STREET ADDRESS		CITY		COUNTY		OFFICE ADDRESS	
ILIFF AND 225		AURORA		ARAPAHOE		ROCKY MOUNTAIN REGION 4643 S. ILLUSTRATION STREET, SUITE 1300, DENVER, COLORADO 80237	
STATE		COLORADO		ARAPAHOE		OFFICE ADDRESS	
50765		39450		50765		39450	
SCALE:		AS NOTED		M&D REF:		BOWAN	
DATE:		04/30/2021		M&D P/C/M:		PROPHET	
DESIGNED BY:		RJP		FILE NAME:		CURRENT.DWG	
DRAWN BY:		RJP		SLS INV. 18-001-111			
CHECKED BY:		RJP					
DRAWING TITLE							
EXISTING CONDITIONS							
SHEET NO.							
2 OF 15

STREET ADDRESS		OFFICE		
ILIFF AND 225		ROCKY MOUNTAIN REGION		
CITY	STATE	COUNTY	CITY	ADDRESS
AURORA	COLORADO	ARAPAHOE	ILIFF AND 225	4643 S. ULLSTER STREET, SUITE 1300, DENVER, COLORADO 80237
STATE STAKE I.D.#		NATIONAL I.D.#		
50765		39450		
REGIONAL DWG. NO.		.		
SCALE:	AS NOTED	M&D REF:	BOWAN	
DATE:	04/30/2021	M&D P/C#	PROPHET	
DESIGNED BY:	RJP	FILE NAME:	CURRENT.DWG	
DRAWN BY:	RJP	CHECKED BY:	RJP	
DRAWING TITLE:				
SITE PLAN				
SHEET NO:				
3 OF 15

GRADING PLAN

FINAL LANDSCAPE PLAN

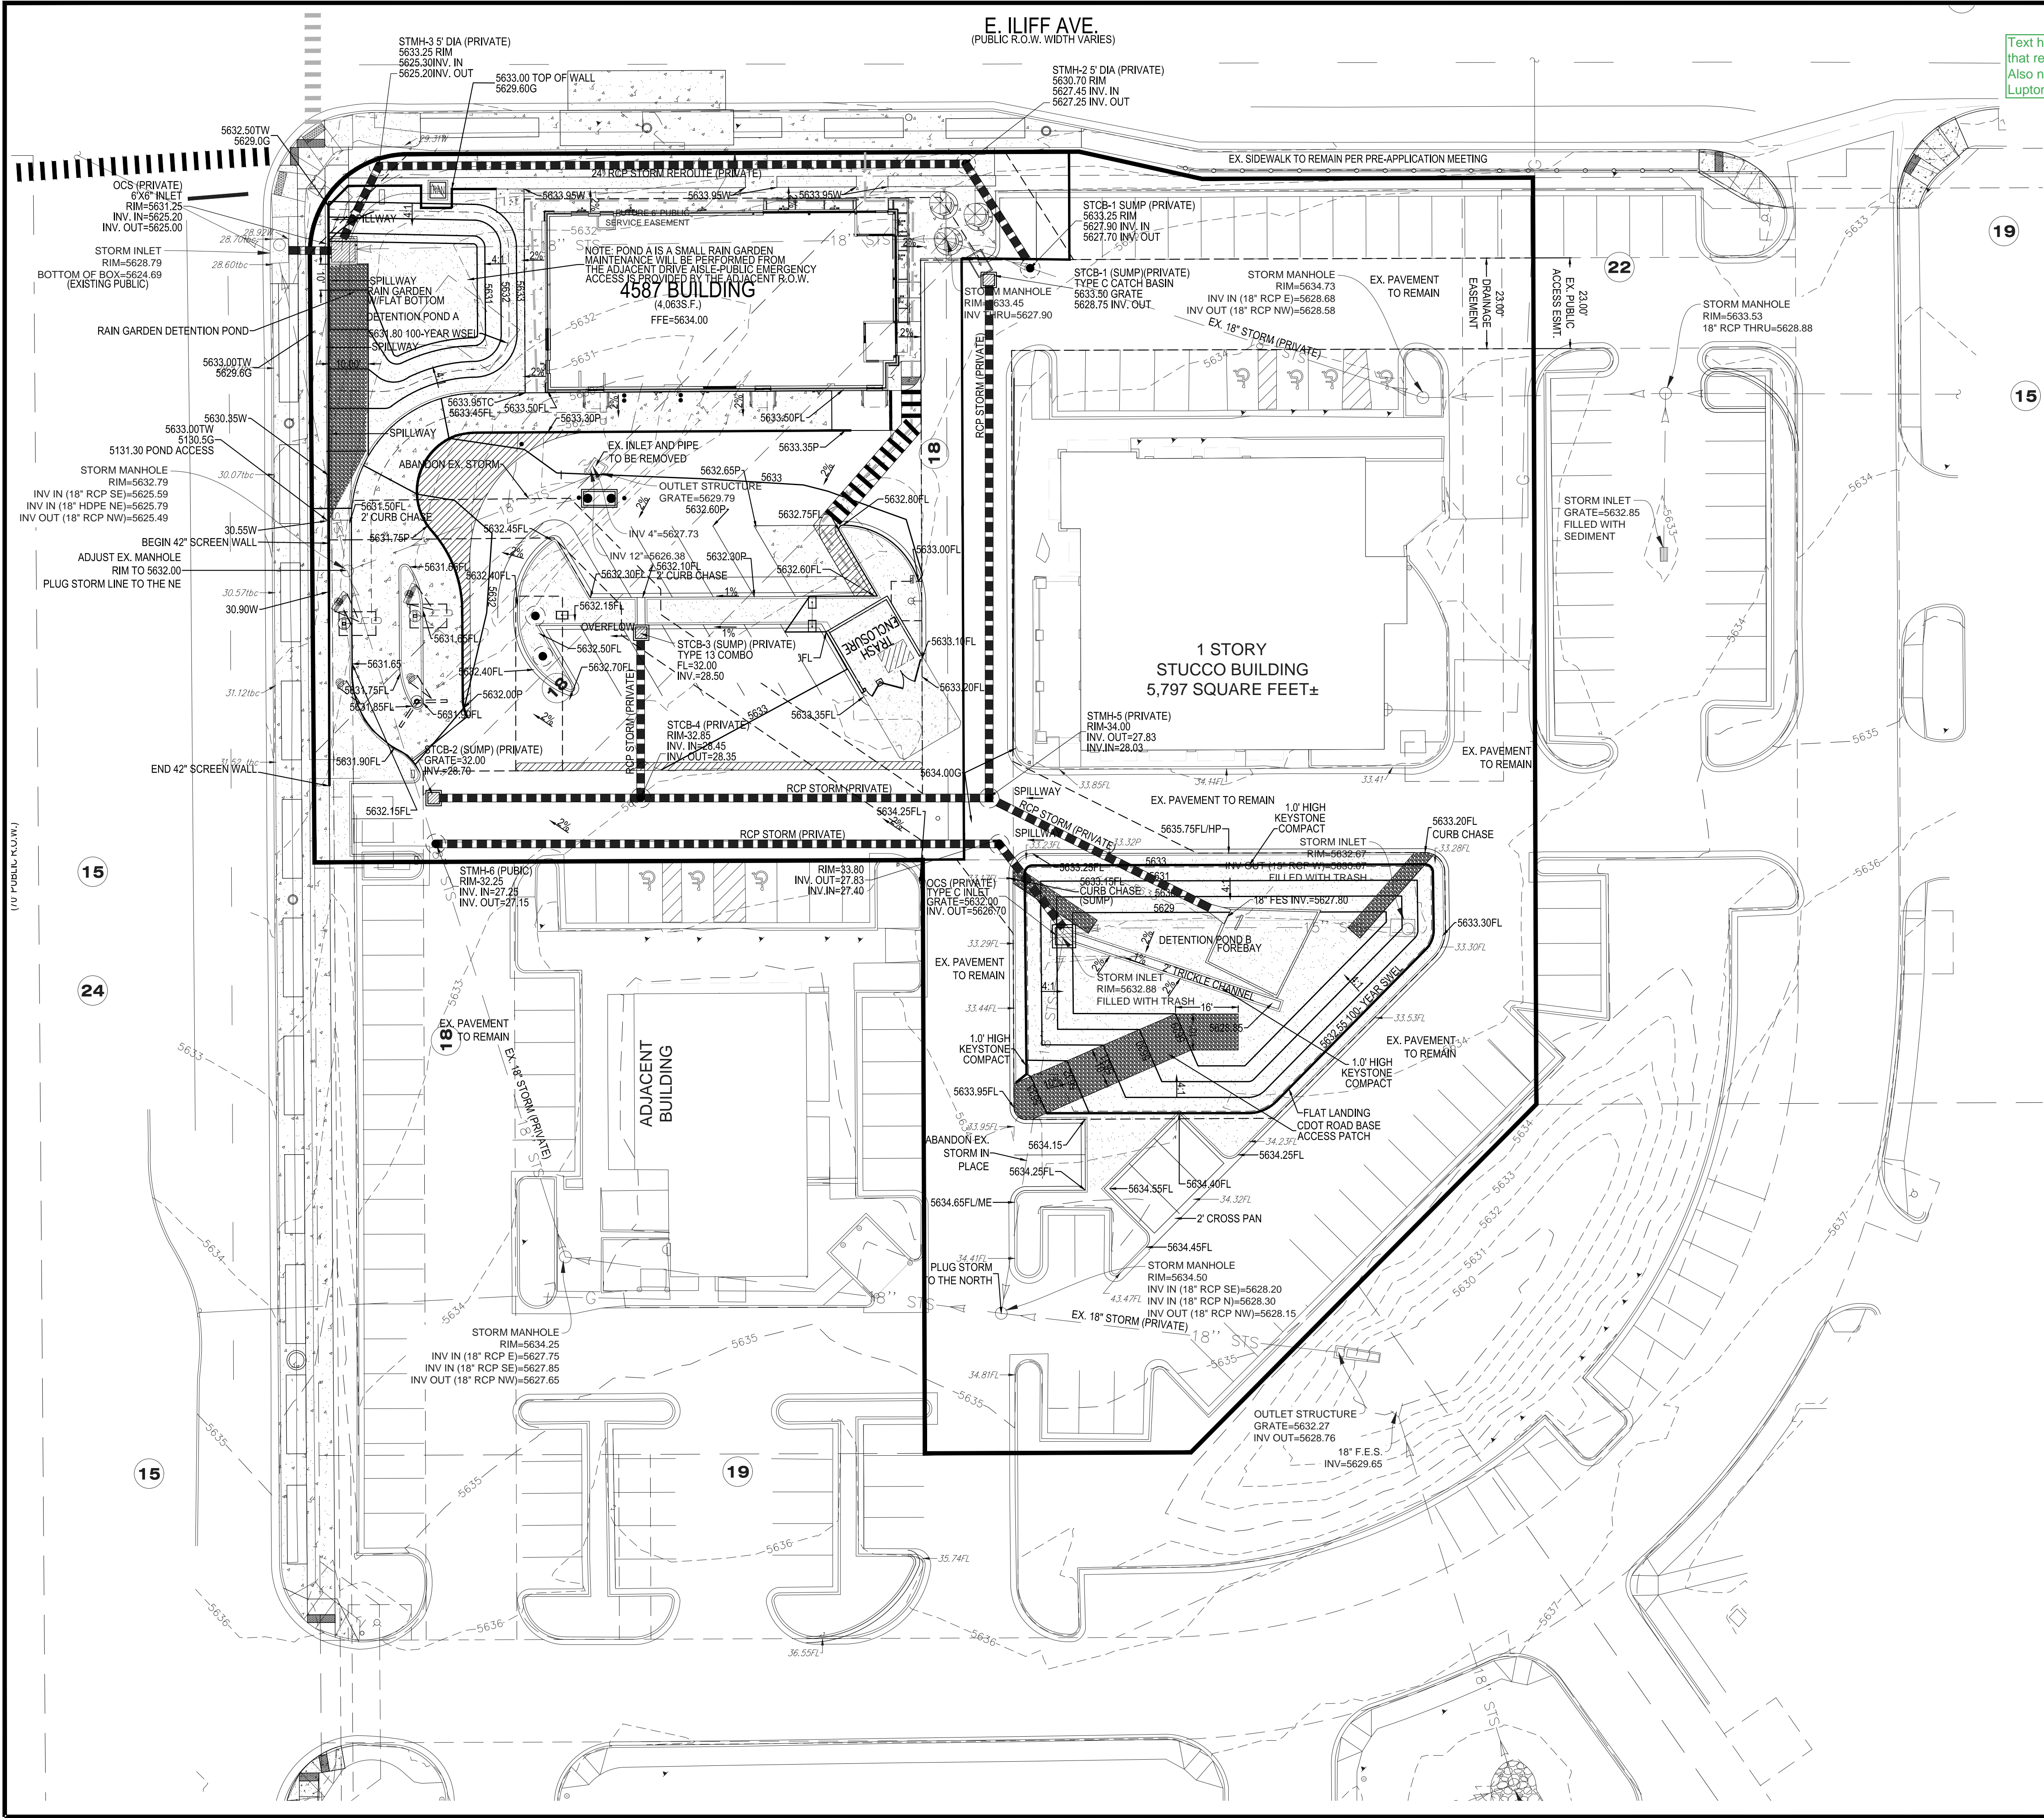
Text height is too small. Remove notes that refer to construction elements. Also notes reference City of Fort Lupton

DRAWING TITLE: UTILITY PLAN

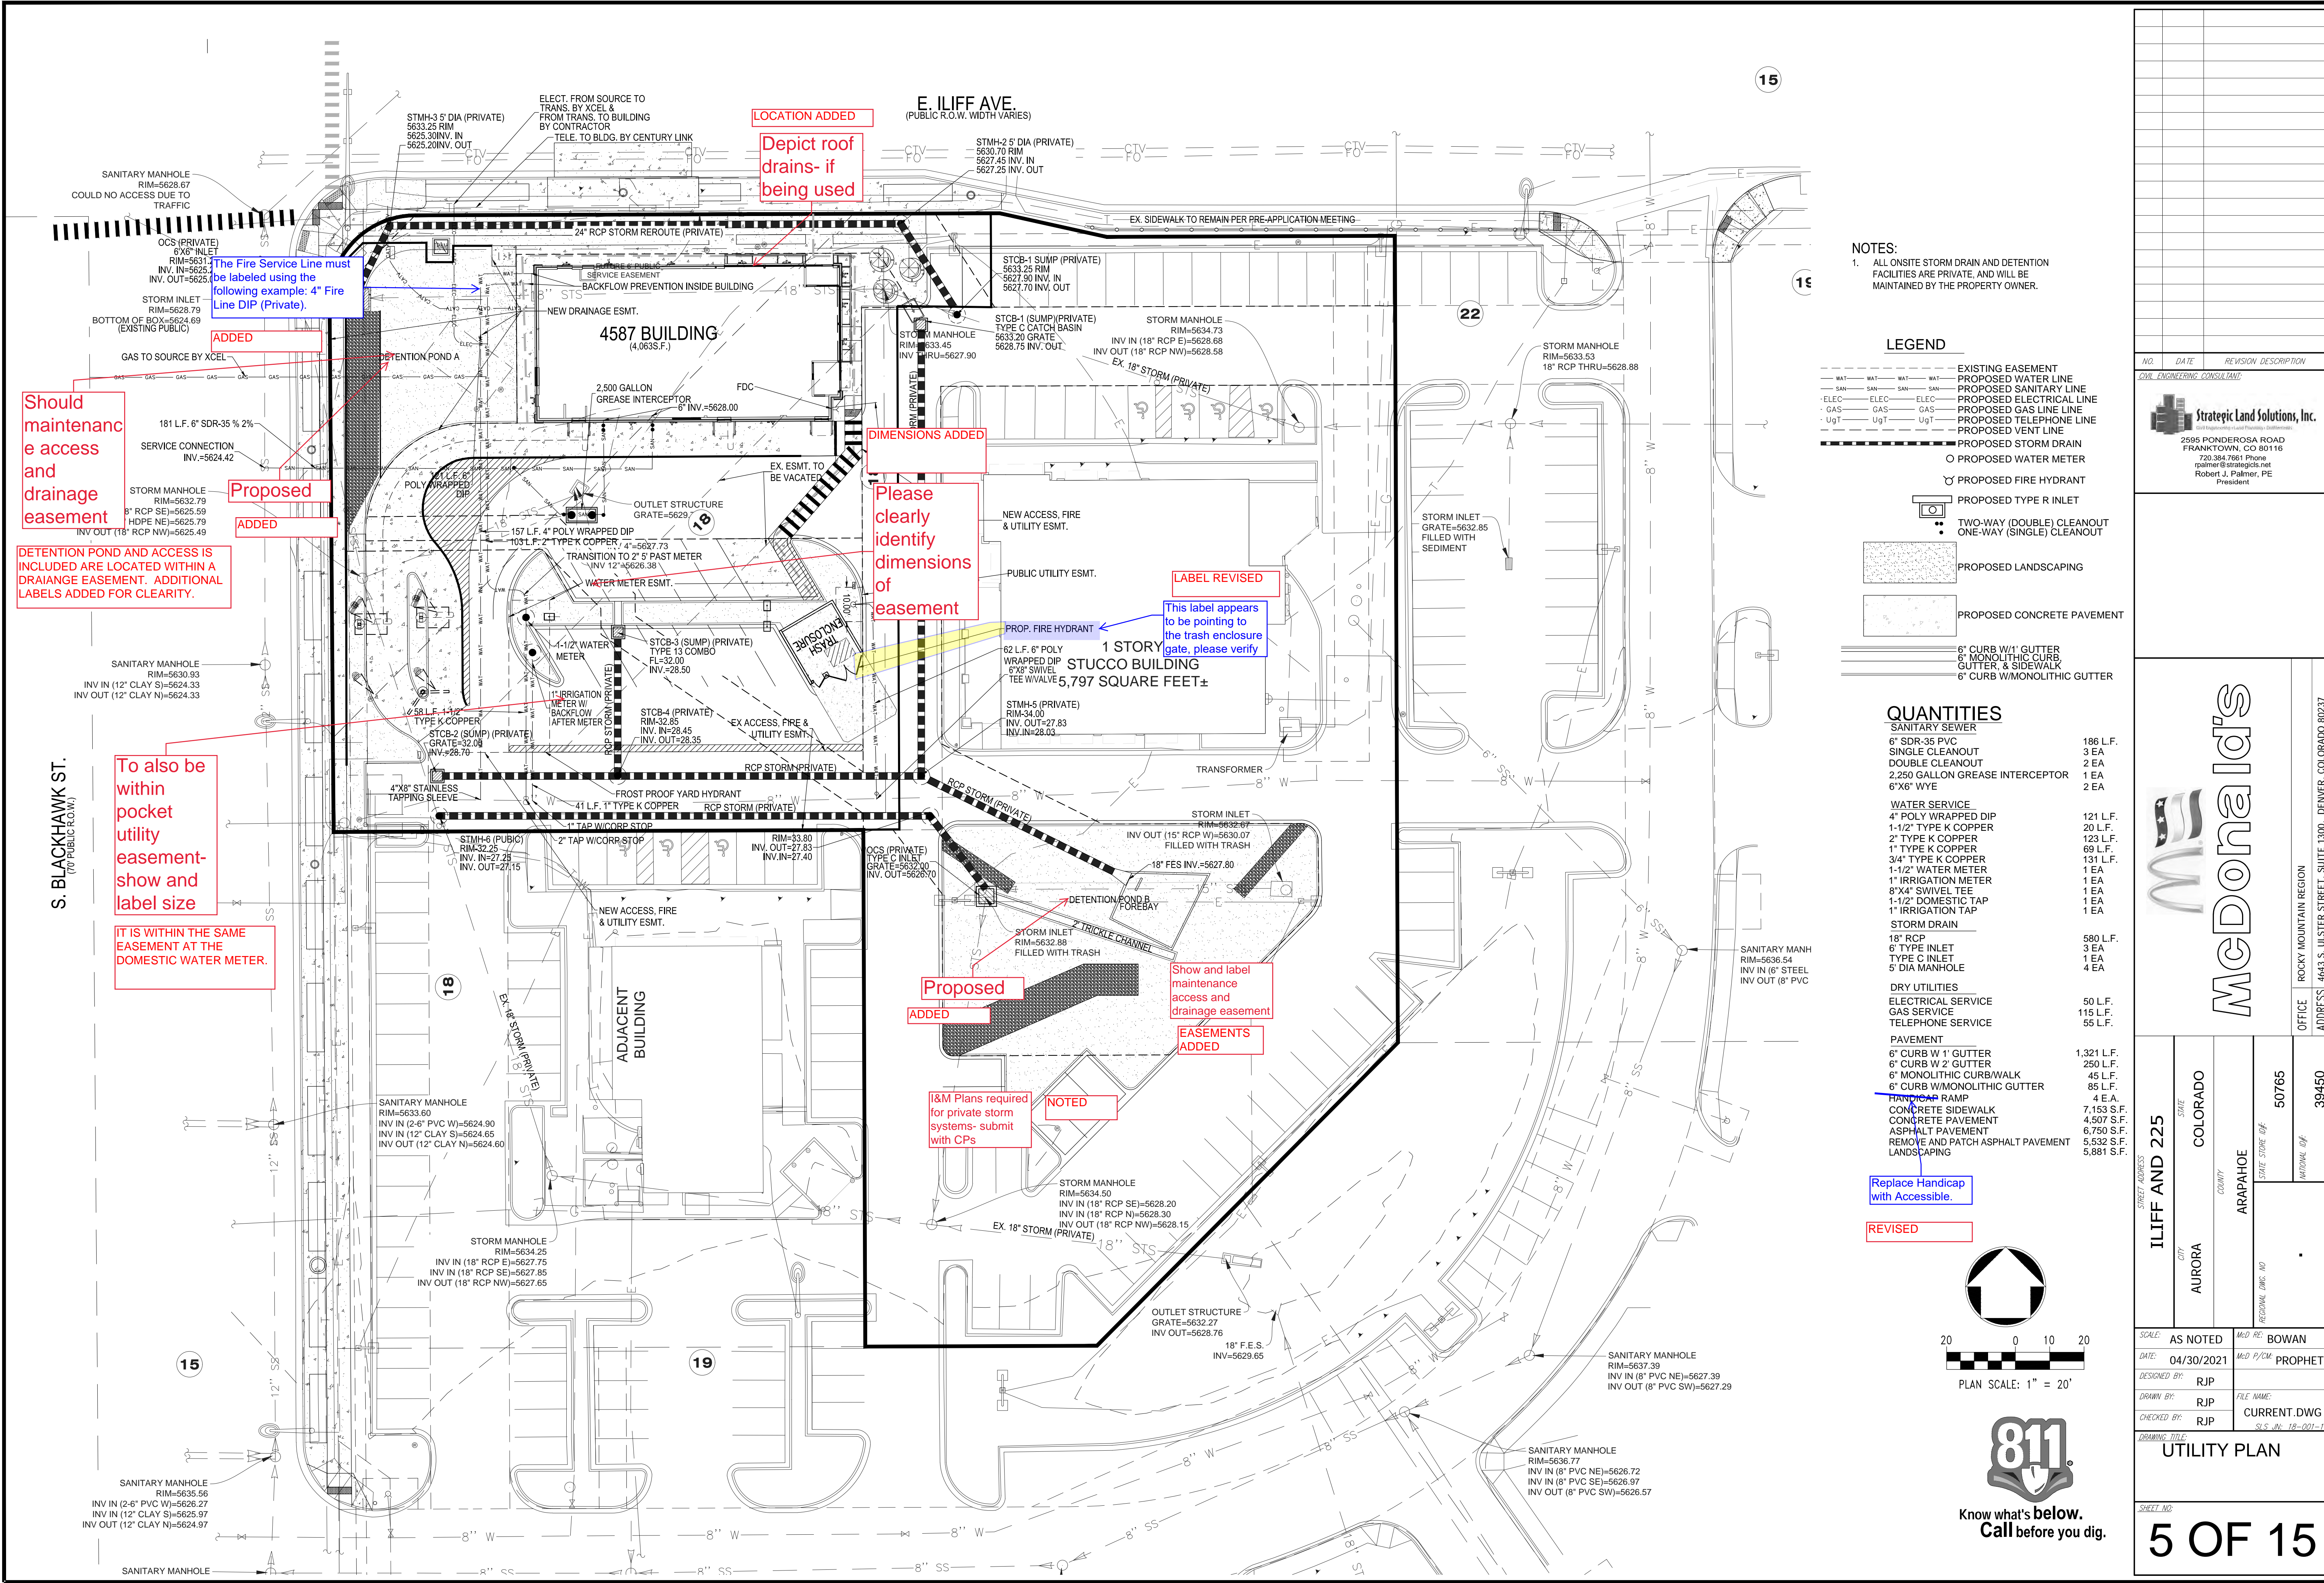
Replace Handicap with Accessible.

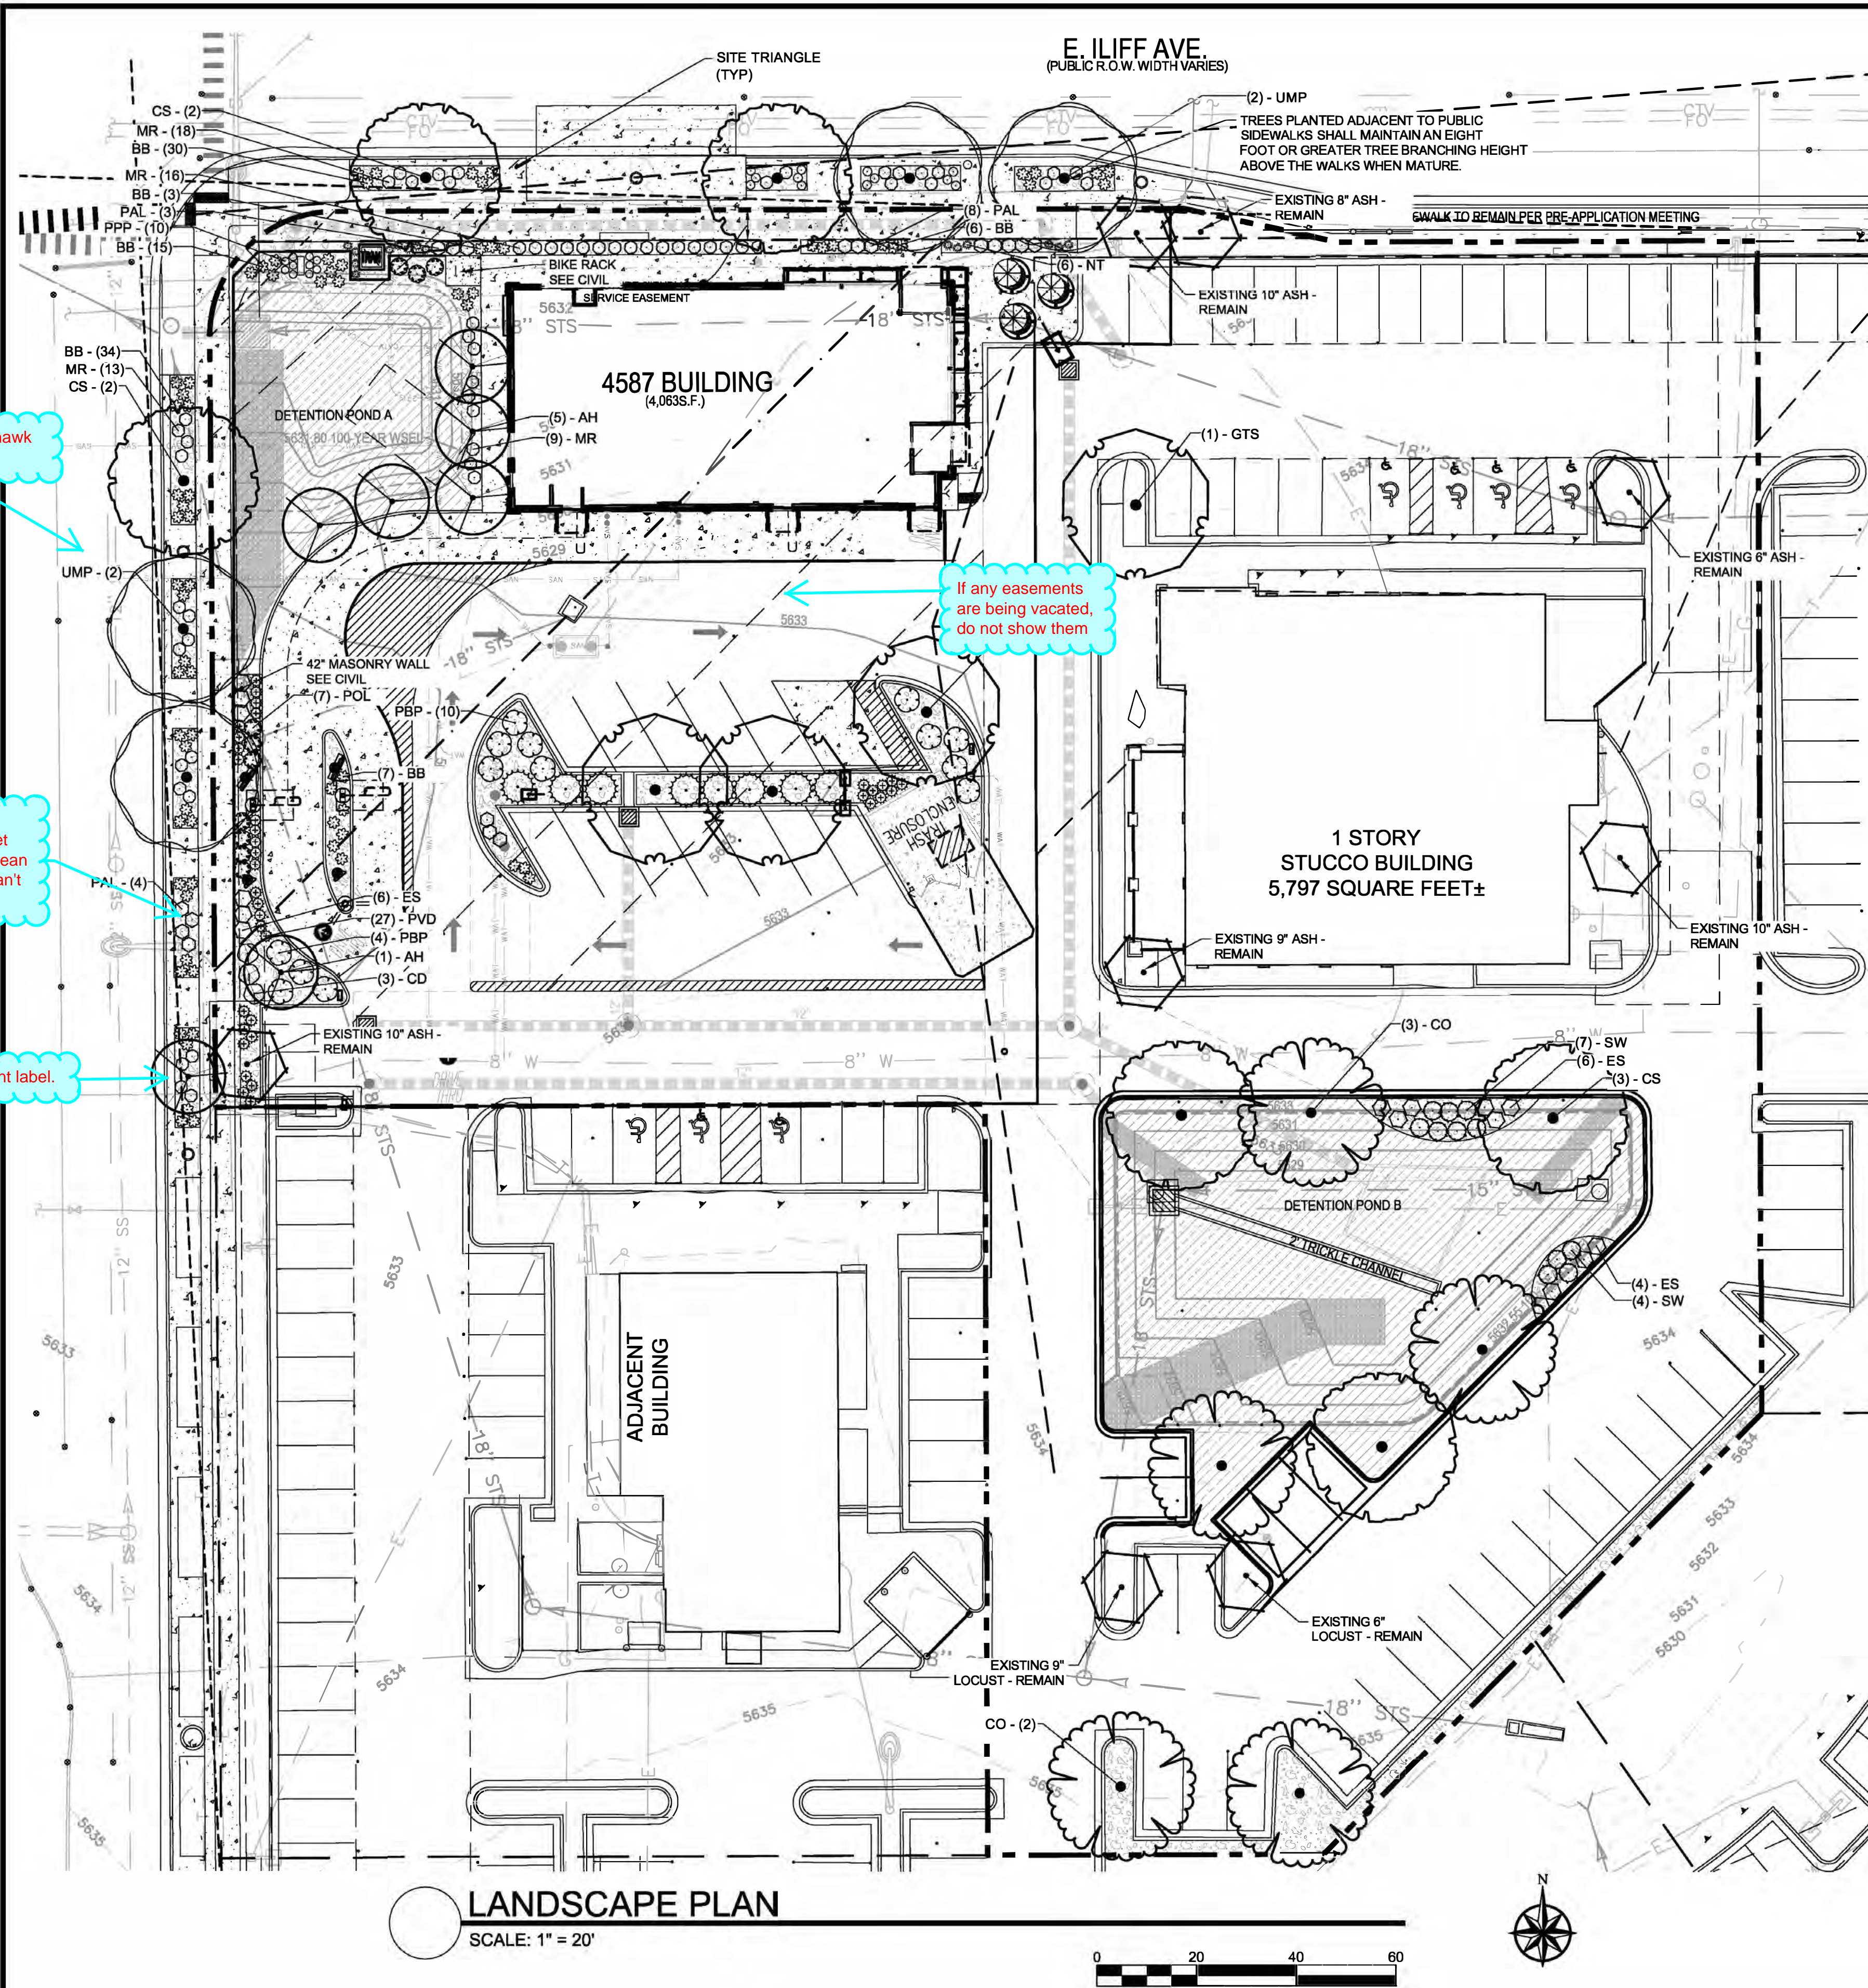
Only 4 are provided and none appear to be existing. If the street tree requirement can not be met, provide an asterisk and an explanation below the table as to why.

Does this belong with the parking lot landscaping?
